FIRE STATION NO. 10 MODIFICATIONS

TITLE: FIRE STATION NO. 10 MODIFICATIONS
ARCHITECTURAL FLOOR PLAN AND DETAILS

RELIANCE STEEL COMPANY
1801 EIGHTH STREET NW.
ALBUQUERQUE, NM 87102

CEILING FRAMING PLAN
(S1)

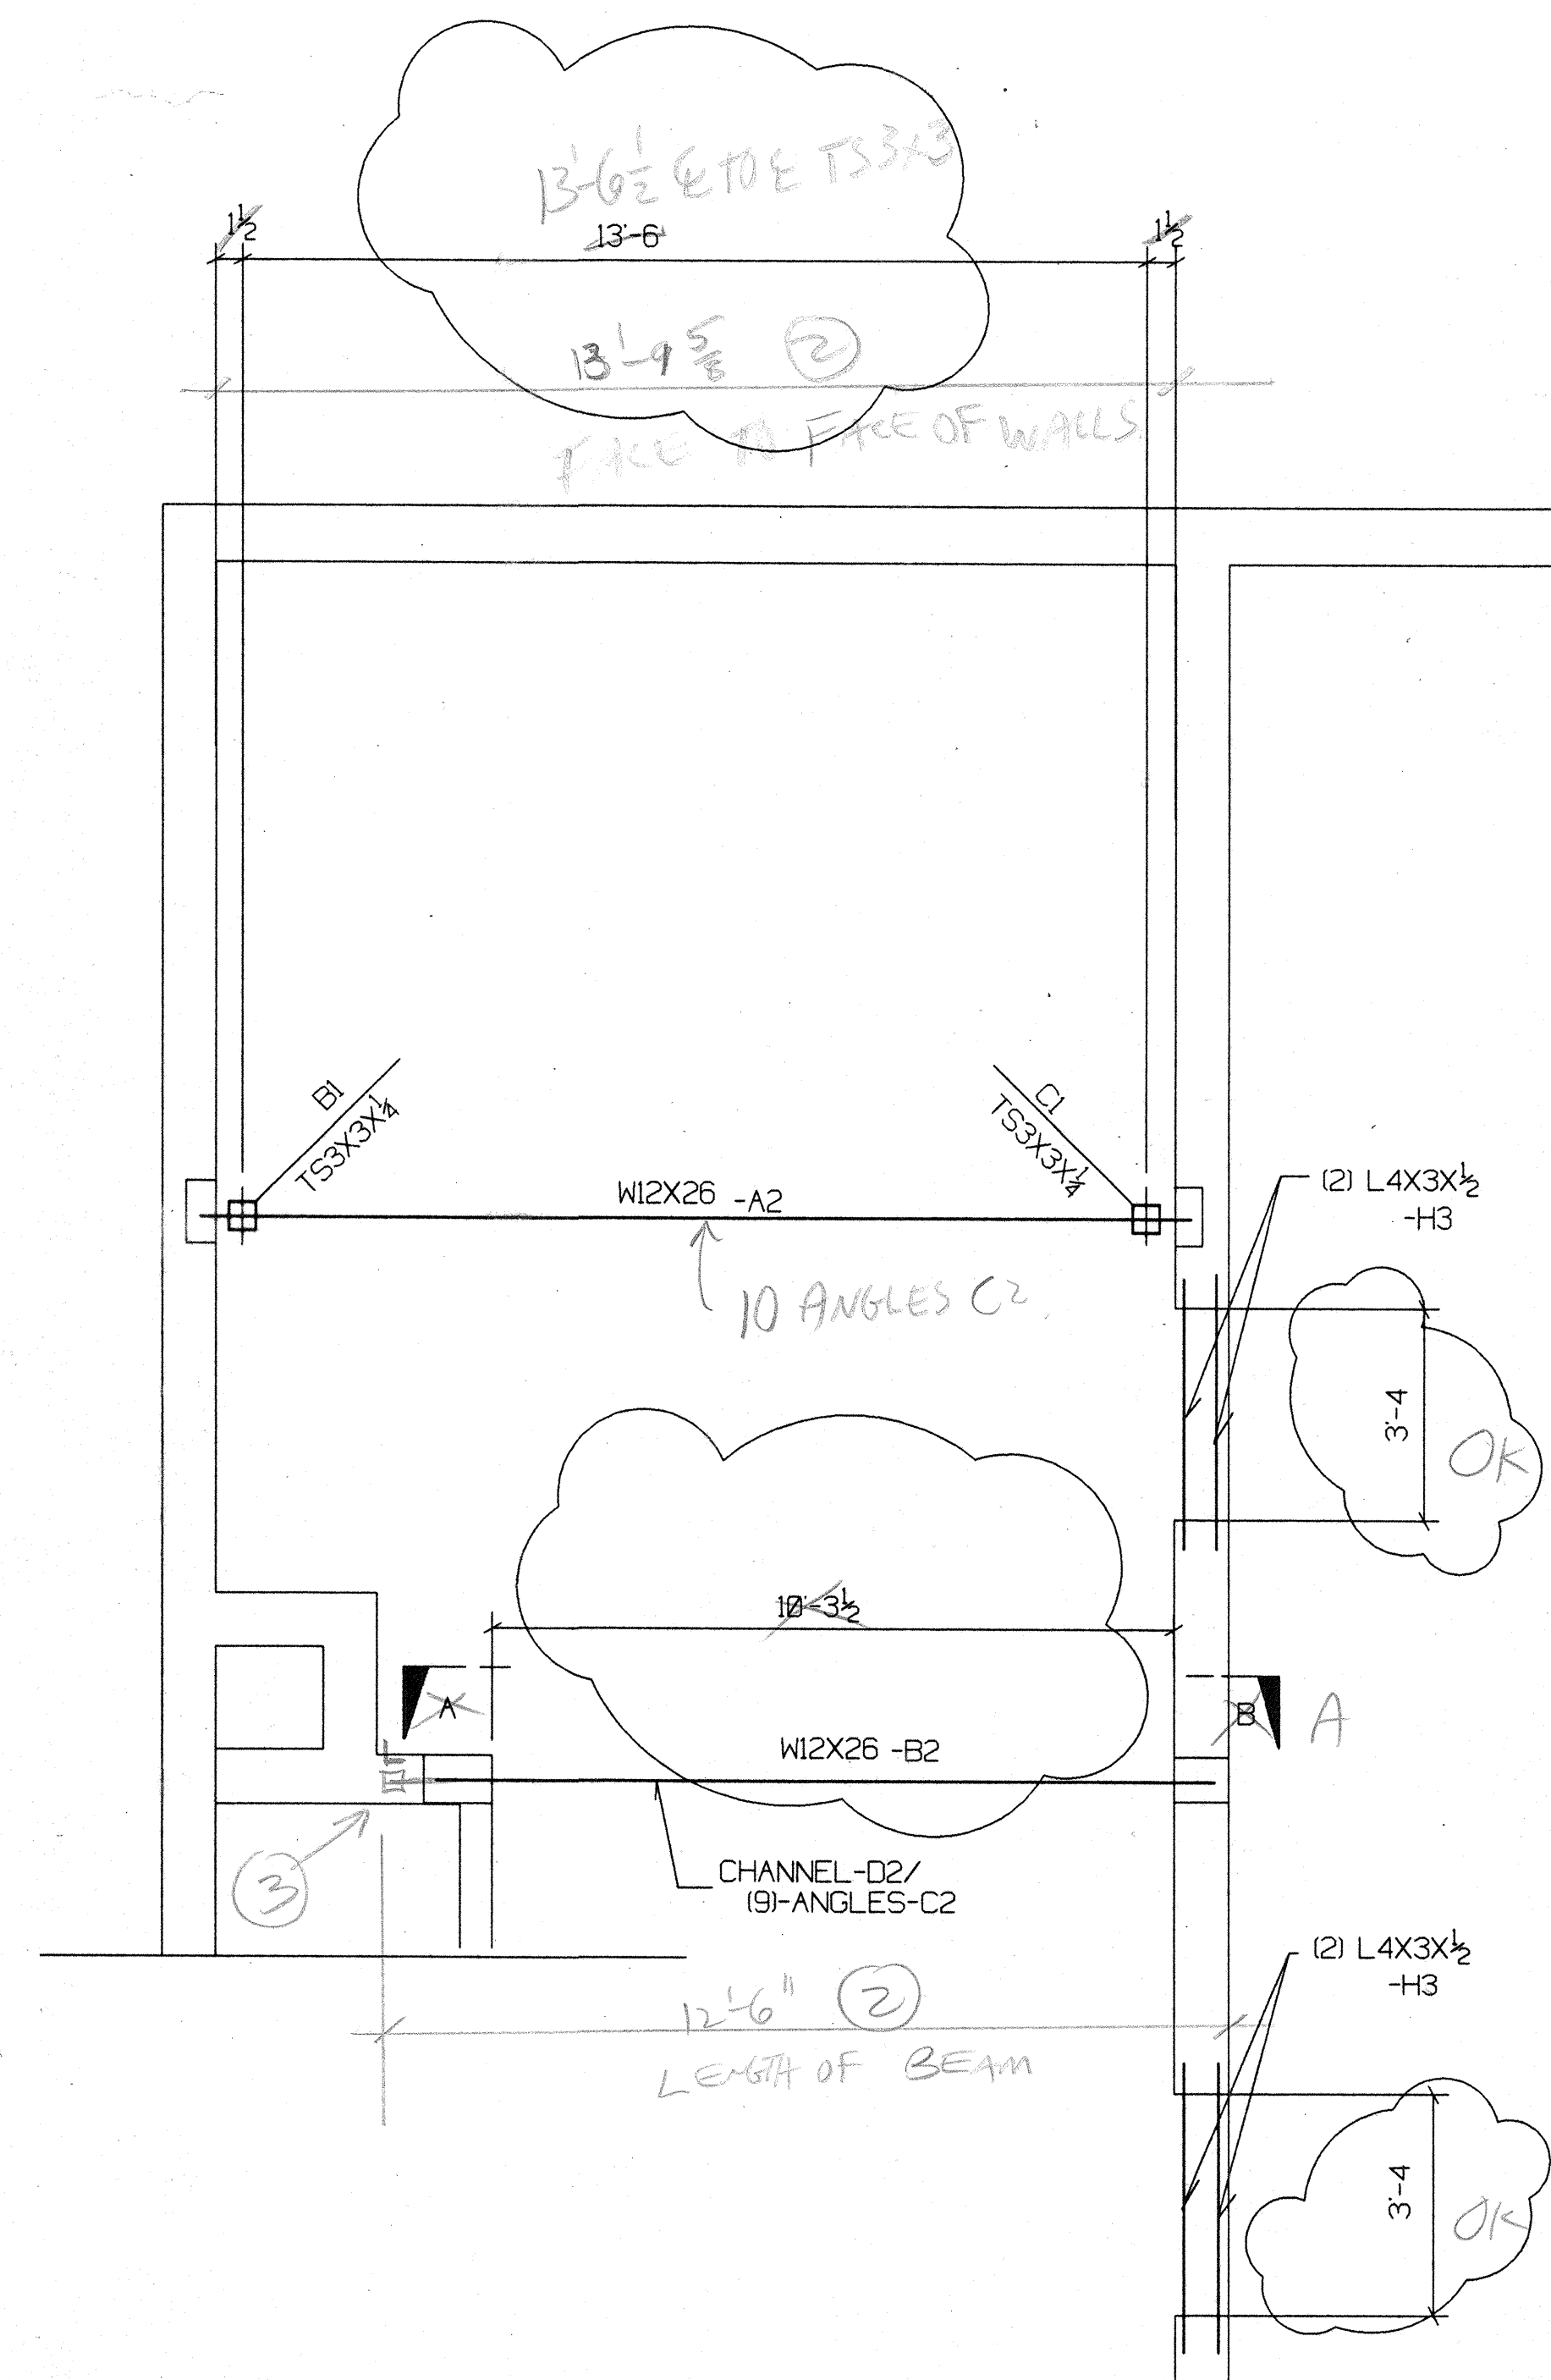
HOLMES & NARVER, INC. ARCHITECTS - ENGINEERS - PLANNERS	
SHOP DRAWING REVIEW	
ACTION	
<input type="checkbox"/>	A. NO EXCEPTIONS TAKEN
<input type="checkbox"/>	B. NO EXCEPTIONS TAKEN SUBJECT TO CORRECTIONS NOTED
<input type="checkbox"/>	C. REVISE & RESUBMIT
<input type="checkbox"/>	D. REJECT - RESUBMIT
H & N REVIEW OF SHOP DRAWINGS FOR COMPLETION. WITH DESIGN INTENT DOES NOT BELIEVE THE CONTRACTOR OF FULL RESPONSIBILITY FOR THE ACCURACY AND ADEQUACY OF CALCULATIONS, DESIGN DETAILS, DIMENSIONS OR QUANTITIES.	
REVIEWER <u>W6</u>	DATE <u>2-23-94</u>
